MDI Return Loss Limit

Aug 16, 2022

Introduction

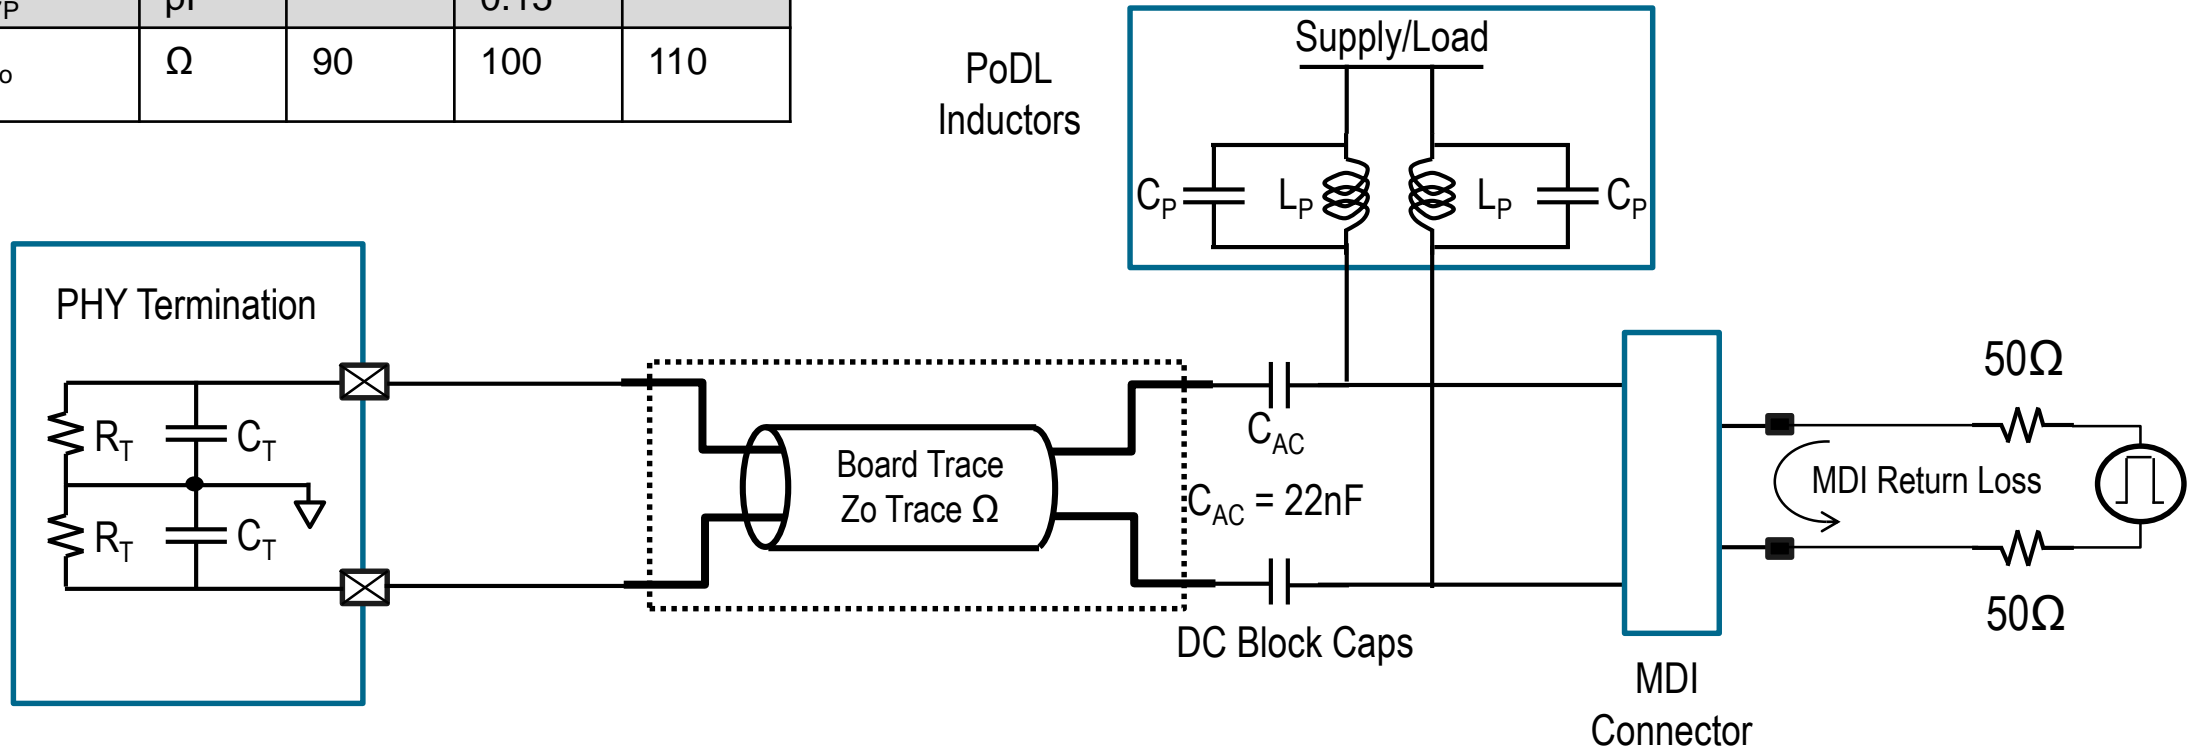
- 802.3cy D2.0 MDI return loss
 - See Equation 165-44 and Figure 165-45
 - Above 50MHz, frequency scaled by 2.5X from 802.3ch
- Question: is this a reasonable spec for practical PHY and board design?
- In this contribution, we present simulation results based on board trace and PHY MDI termination impedance models
 - Both non-PoDL and PoDL cases considered
- A new MDI return loss spec will be proposed at the end based on these results

Conclusion

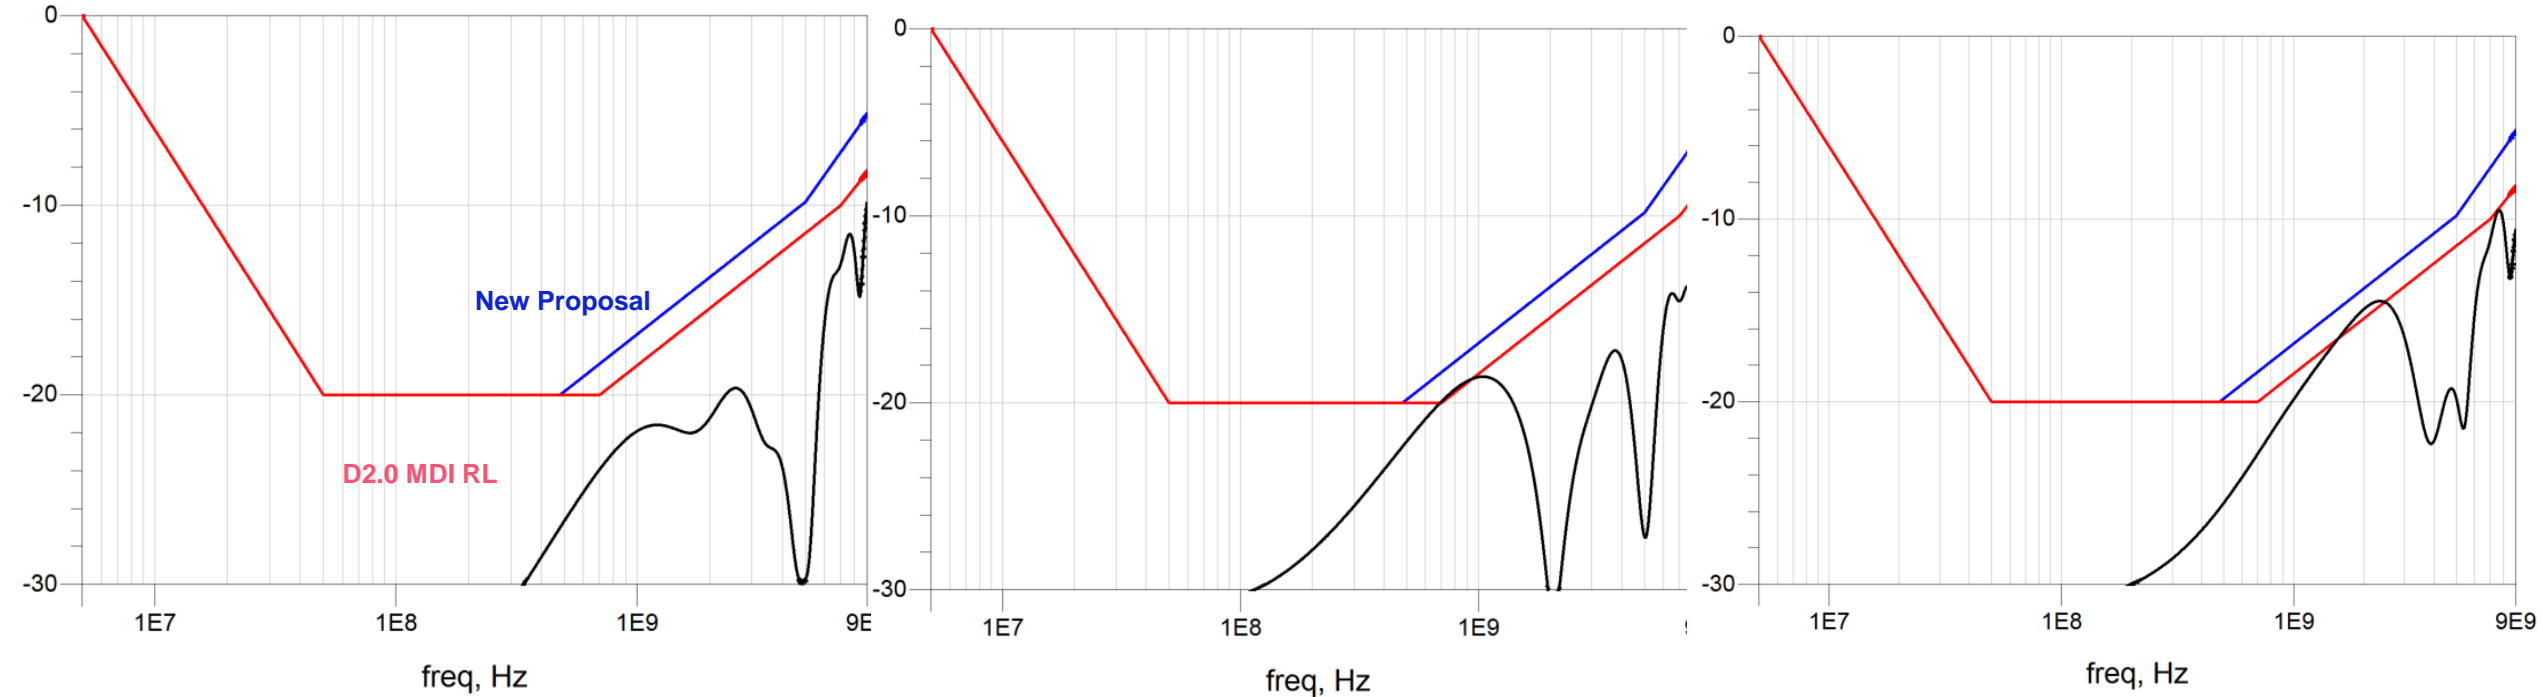
- The D2.0 MDI return loss spec is too restrictive for practical PHY and board implementations
- A new MDI return loss is proposed
- With the new proposal, board traces between 0.75 in and 1.5 in seem to be feasible

New Proposal:

$$\text{Return Loss} = \left[\begin{array}{ll} 20 - 20(\log_{10} \frac{50}{f}) & 5 \leq f \leq 50 \\ 20 & 50 \leq f \leq 480 \\ 20 - 10\log_{10}(f / 480) & 480 \leq f \leq 4800 \\ 10 - 18\log_{10}(f / 4800) & 4800 \leq f \leq 9000 \end{array} \right] \text{ (dB)}$$
